PCN#03C-14 supersedes PCN#03B-14
see PCN history for change descriptions.

Subject: PCN#03C-14 Notification of Intent to Utilize an Alternate Qualified Assembly Site/Test Site and/or Alternate Qualified Material Sets for Select Lattice Products

Affected Products

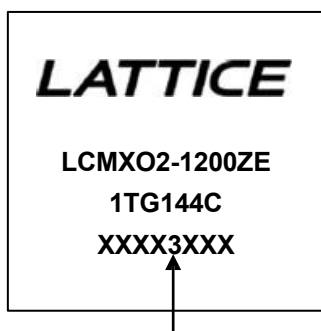
In an effort to expand Copper bond wire (Cu-wire) manufacturing capacity, Lattice will now use Amkor Philippines for select devices. Amkor Philippines utilizes industry standard raw material, assembly and test processes. The use of these alternate qualified material sets will not change external package dimensions. The package footprints remain the same and are published on the [Lattice website](#).

The Ordering Part Numbers (OPNs) affected by this PCN are listed in an Excel spreadsheet [here](#). This PCN also affects any custom devices (i.e. factory programmed, special test, tape and reel, non-standard speed grade and package, etc.), which are derived from any of the devices listed in the table.
